Village of Bayside 9075 N Regent Road Architectural Review Committee Meeting August 15, 2022 Village Board Room, 6:00pm

ARCHITECTURAL REVIEW COMMITTEE AGENDA

VILLAGE CODE REVIEW

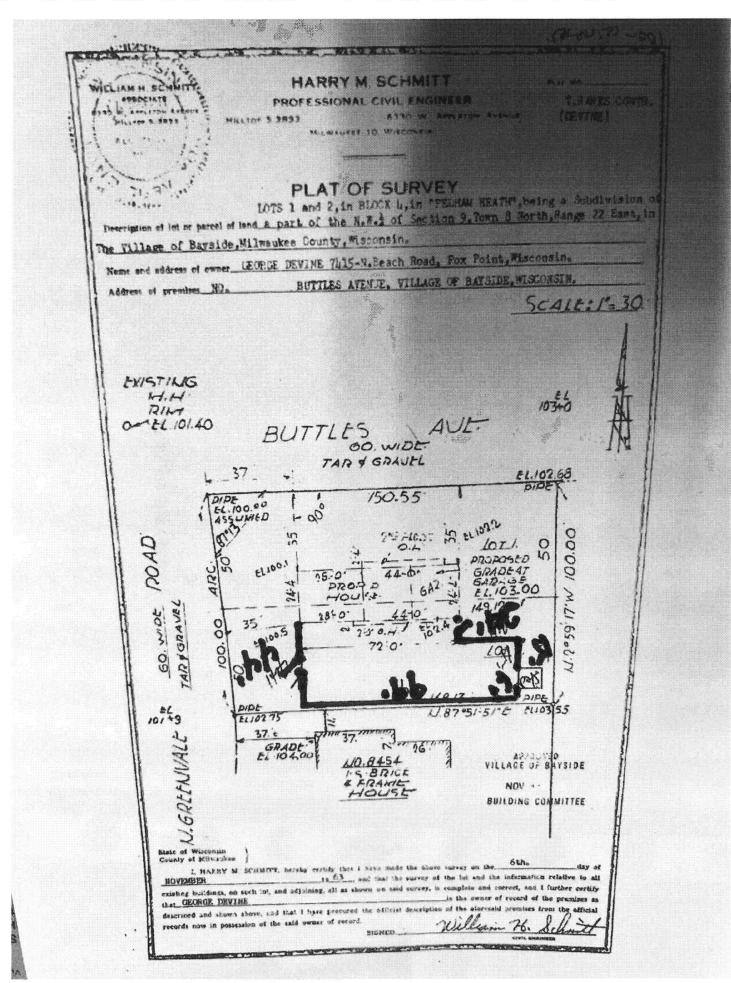
- 1. Current fence ordinance 104-125 (C) does not allow fences to exceed 50% of the perimeter of the property. The perimeter of the property is approximately 495.5 feet. The applicant states the proposed fence is 190 feet. This is 38.35% of the perimeter of the property. This is compliant with the ordinance.
- 2. The height of the fence is 4 feet open design, which is compliant with the ordinance.
- 3. A current survey was provided.
- 4. Pictures were included for their neighboring fences
- 5. The board always considers matching fences with neighboring fences.

AUDUBON 333 W. BROWN DEER ROAD BAYSIDE, WI 53217

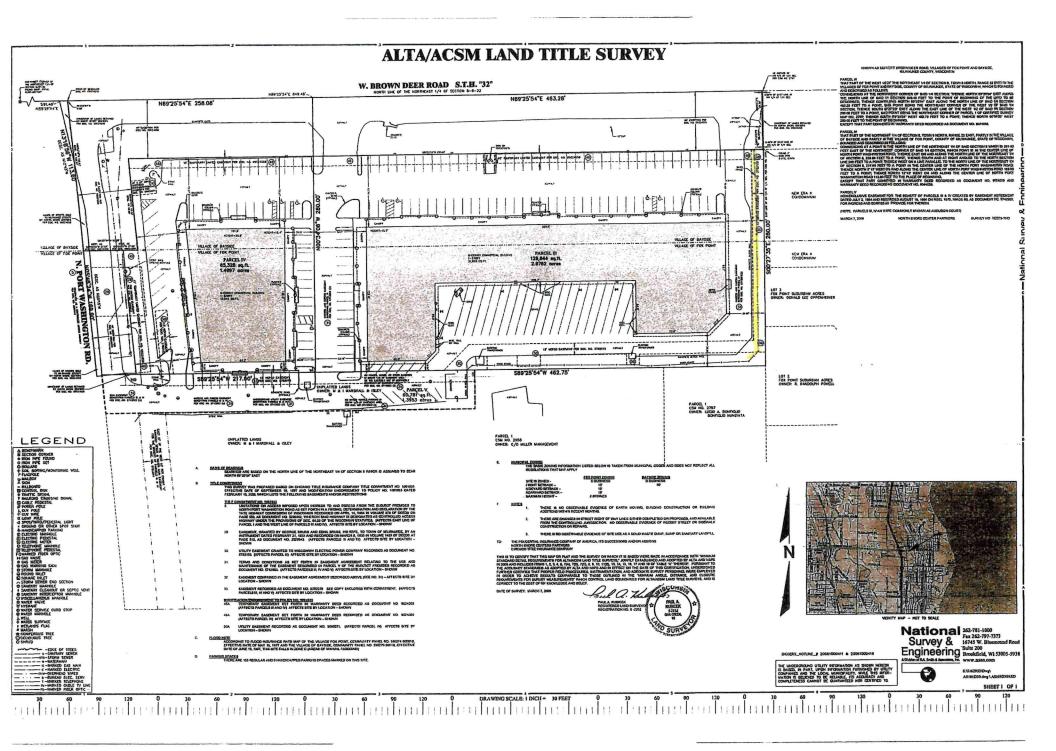
- 1. Current fence ordinance does not allow fences to exceed 50% of the perimeter of the property. The applicant states the proposed fence is 95 feet. This is compliant with the ordinance.
- 2. The height of the fence is 6 feet privacy design,
- 3. A current survey was provided.
- 4. The board always considers matching fences with neighboring fences.

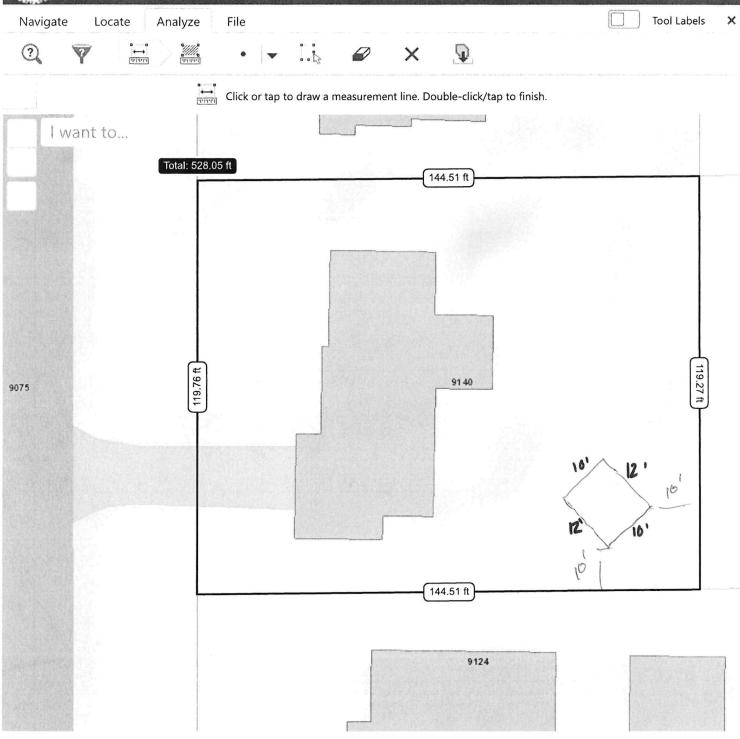
- (4) A side yard of not less than ten feet shall be provided for on each side of every building.
- (5) A rear yard of not less than 20 feet shall be provided for every building, except one of not less than ten feet shall be provided for a building used for or classified as an accessory use.
- 1. Confirms with required setbacks
- 2. Confirms with the Impervious requirements

Plat of Survey

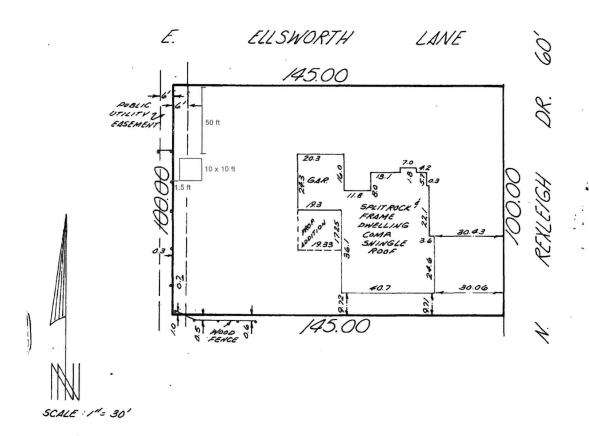
- (4) A side yard of not less than ten feet shall be provided for on each side of every building.
- (5) A rear yard of not less than 20 feet shall be provided for every building, except one of not less than ten feet shall be provided for a building used for or classified as an accessory use.
- 1. Does not Confirms with required setbacks. Per Village staff "Approved by Board of Zoning Appeals for setback and Board of Trustees pending ARC approval"
- 2. Confirms with the Impervious requirements
